ORIGINATION FORM

Proposed Revisions to a Standard Plans Index

Index Number: 654-001

Index Title: Rectangular Rapid Flashing Beacon Assembly

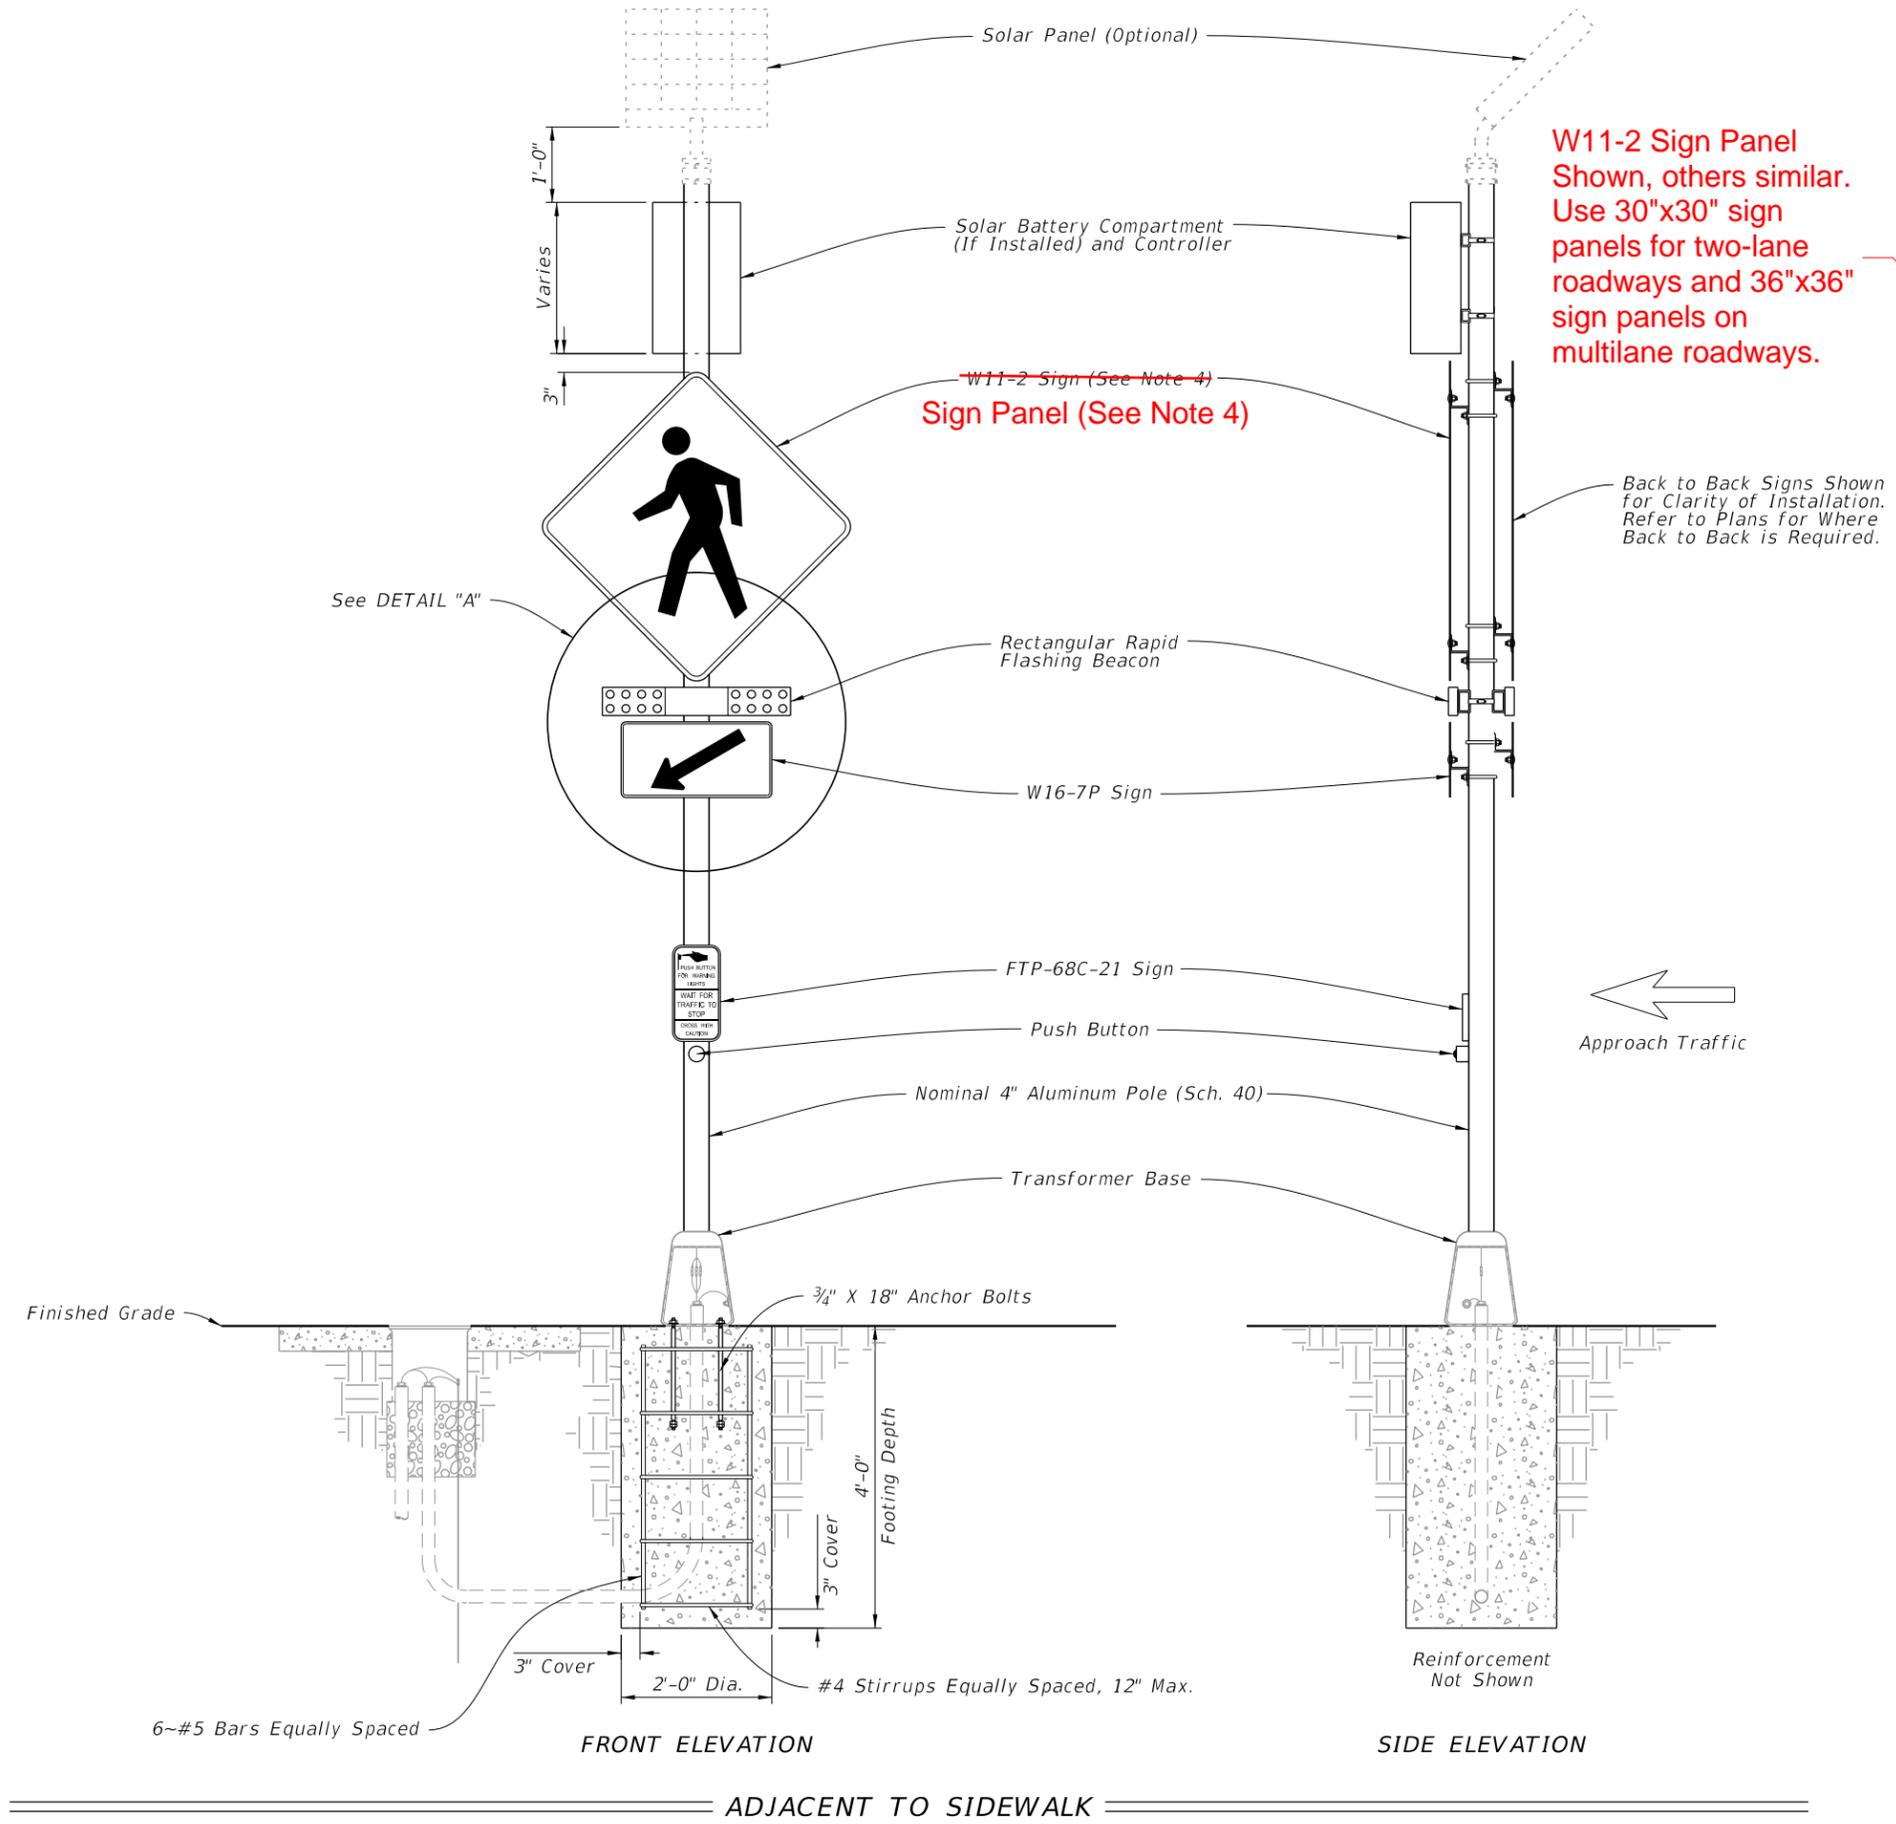
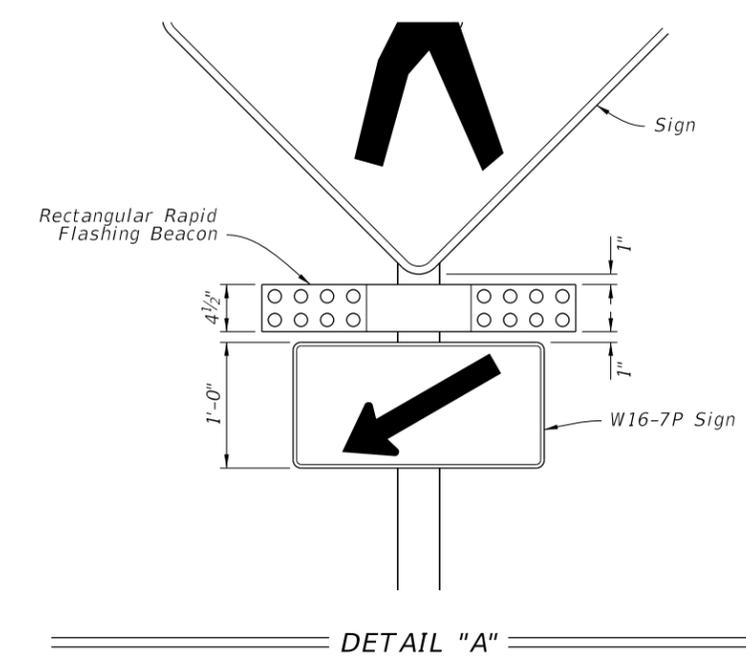
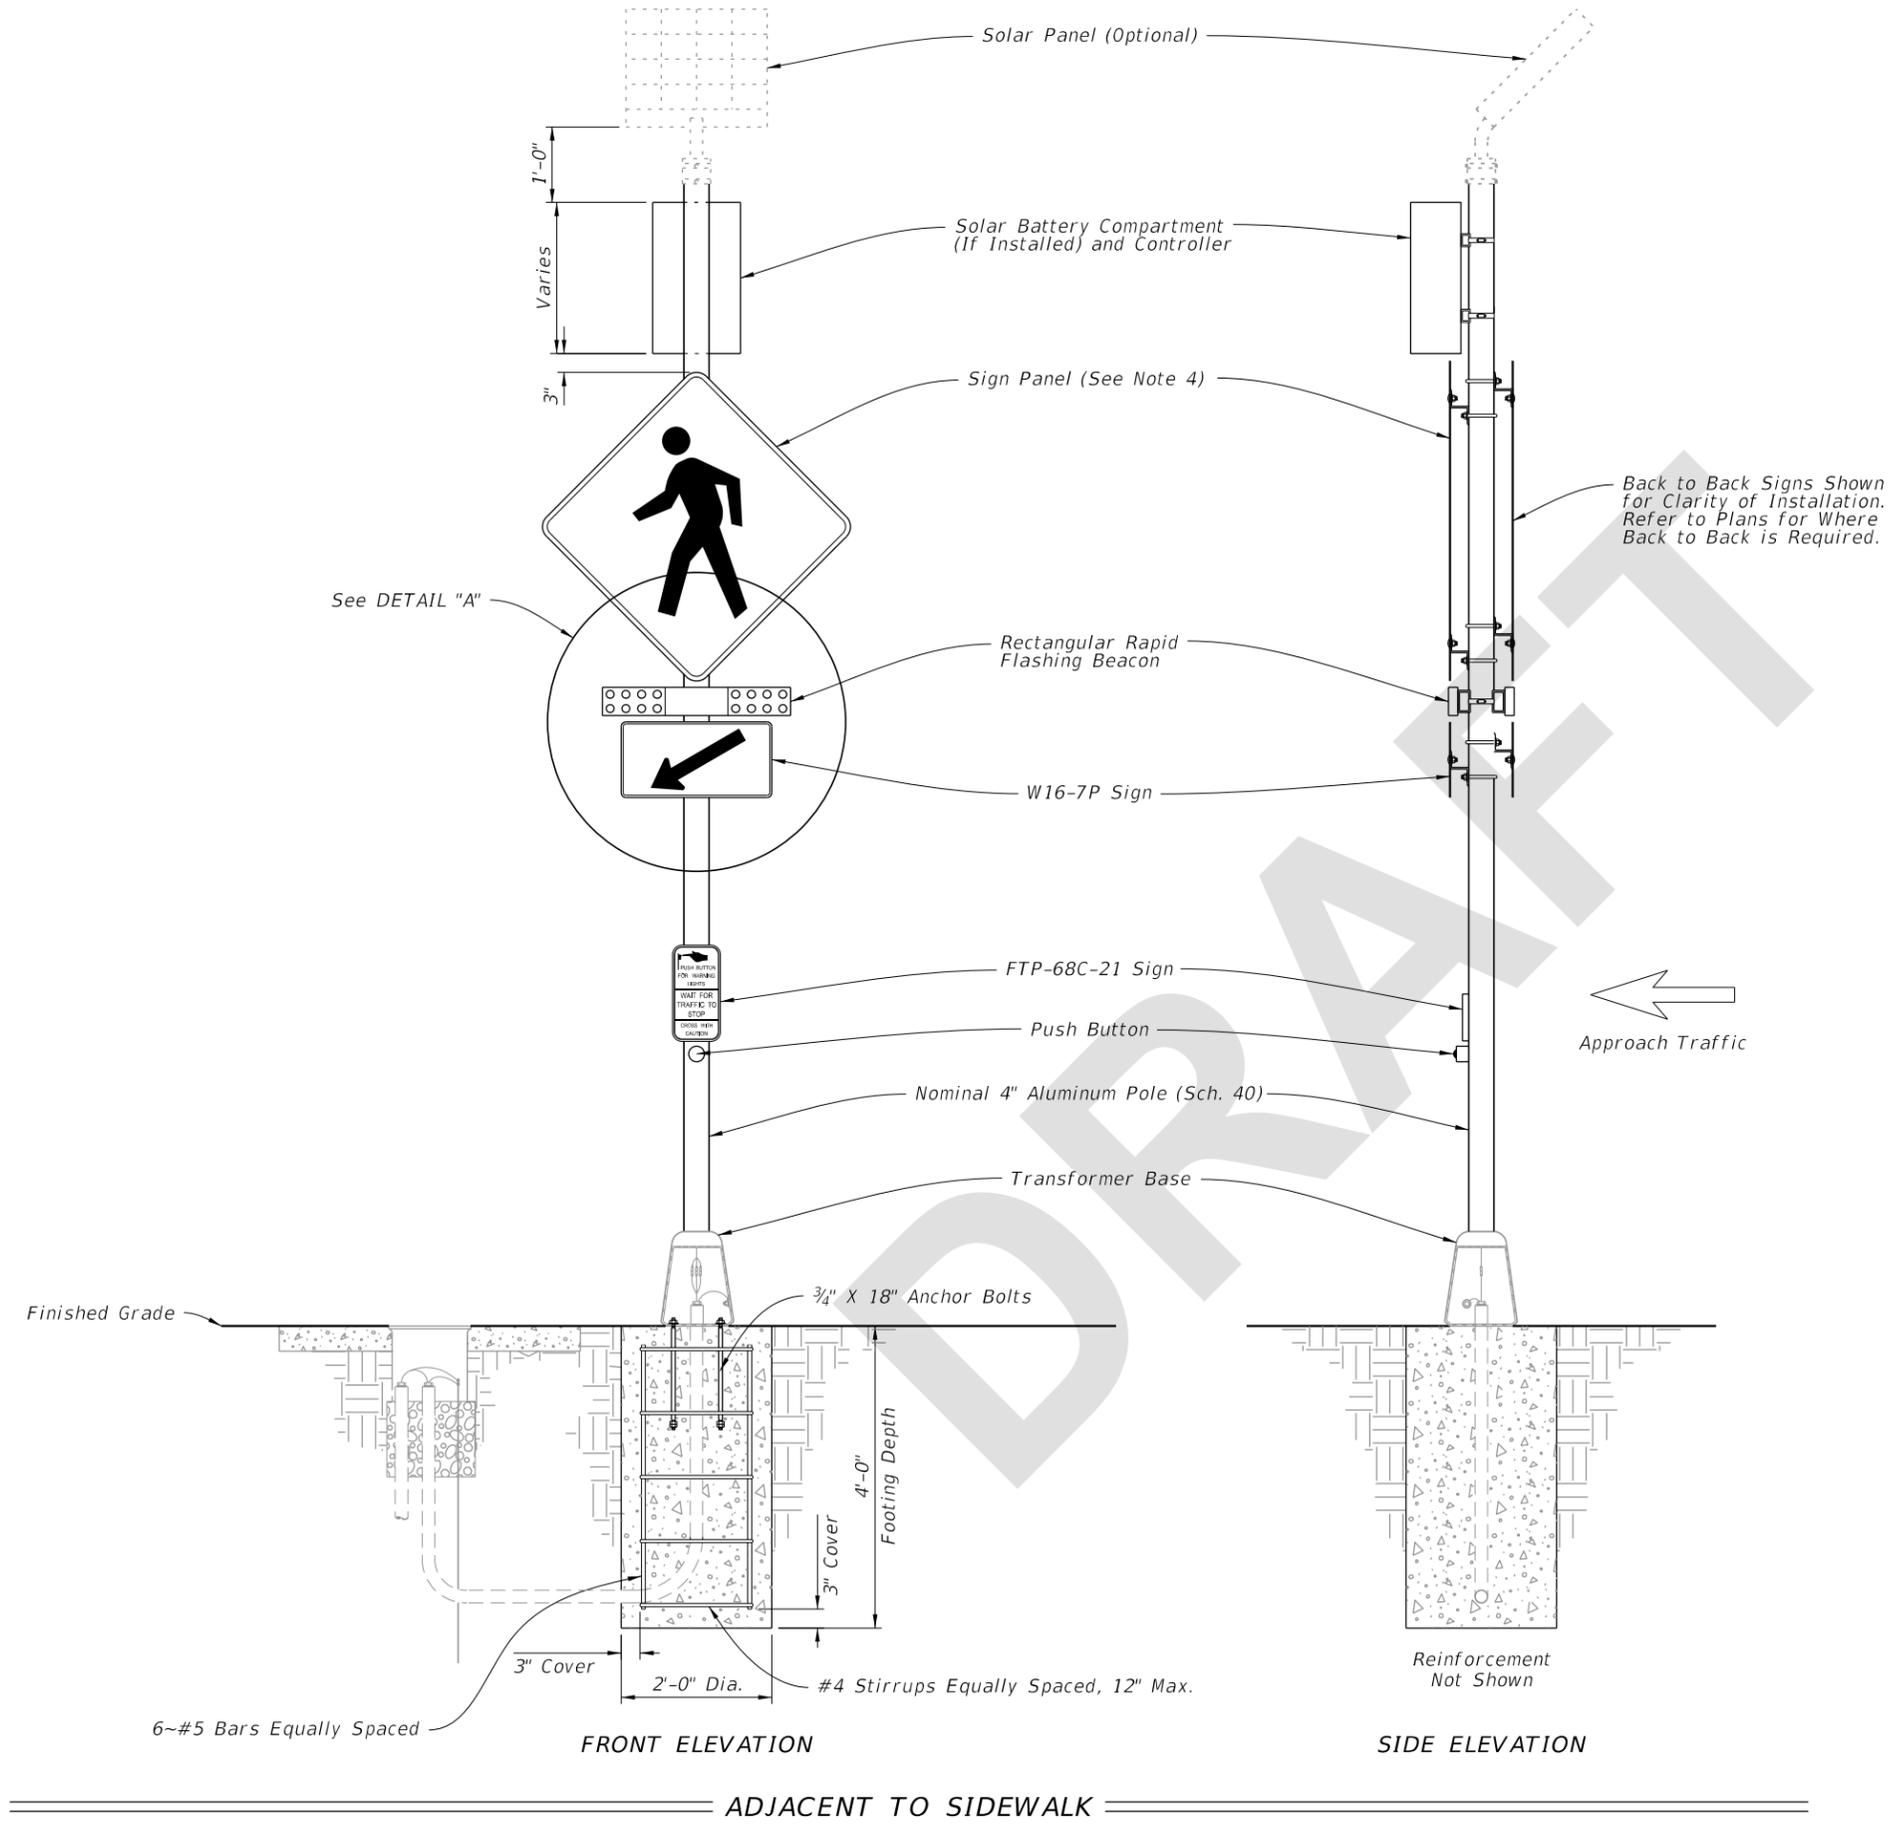
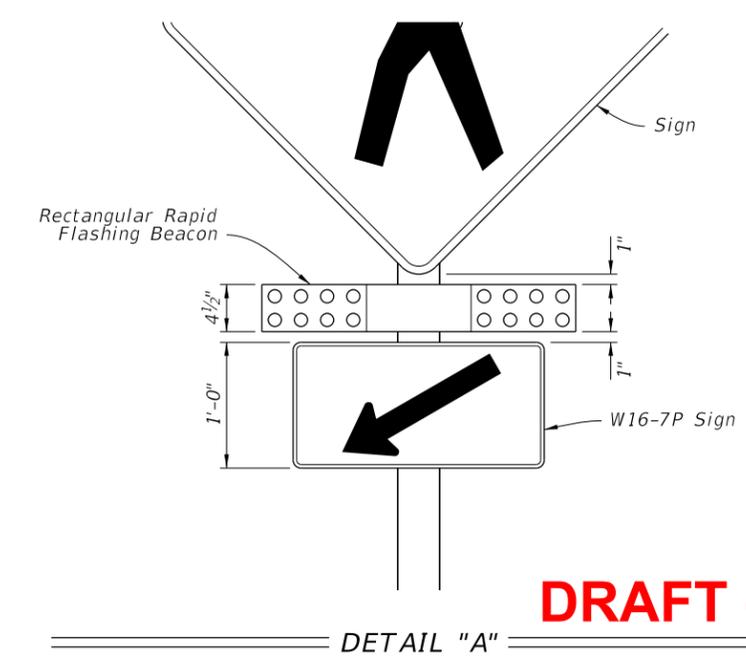
Sheet 1: Updated Note 4 to "W11-2 Sign Panel Shown, others similar. Use 30"x30" sign panels for two-lane roadways and 36"x36" sign panels on multi-lane roadways. Updated callout to "Sign Panel (See Note 4)". Added Note 12, "In lieu of footing design shown, a Spread Footing may be used in accordance with index 700-120."

Note 4 and callouts were updated at the request of the TERL to allow for various sign options.

Note 12 was added because of new spread footing design option in Standard Plans Index 700-120.

W11-2 Sign Panel
Shown, others similar.
Use 30"x30" sign
panels for two-lane
roadways and 36"x36"
sign panels on
multilane roadways.

2. Install the RRFB in pairs, one on either side of approach traffic.
 3. Install controller on the backside of post from approach traffic.
 4. ~~Install a 30" X 30" W11-2 sign on two-lane roadways and a 36" X 36" W11-2 sign for multilane roadways.~~

12. In lieu of footing design shown, a Spread Footing may be used in accordance with Index 700-120.

2. Install the RRFB in pairs, one on either side of approach traffic.
 3. Install controller on the backside of post from approach traffic.
 4. W11-2 sign panel shown, others similar. Use 30" X 30" sign panels for two-lane roadways and 36" X 36" sign panels on multilane roadways.

12. In lieu of footing design shown, a Spread Footing may be used in accordance with Index 700-120.
